STAFF RECOMMENDATION 853 A Bradford April 20, 2016

Application: New construction – addition and detached accessory dwelling unit;
Setback determination

District: Waverly Belmont Neighborhood Conservation Zoning Overlay

Figure 2: 1951 Sanborn Map

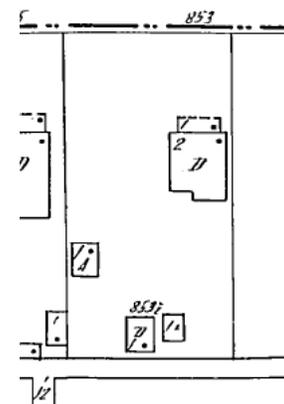
Since the footprint of the DADU exceeds seven hundred (700 sq. ft.), the required rear setback per the Zoning Code is twenty feet (20'). The applicant requests that the rear setback be reduced to ten feet (10'). Staff finds that the proposed rear setback is appropriate as it is consistent with other outbuildings in the immediate area and locating the outbuilding closer to the property line is historically appropriate. Sanborn maps from 1951 show an accessory dwelling unit on this site that is located in the rear yard close the alley. (See Figure 2.)
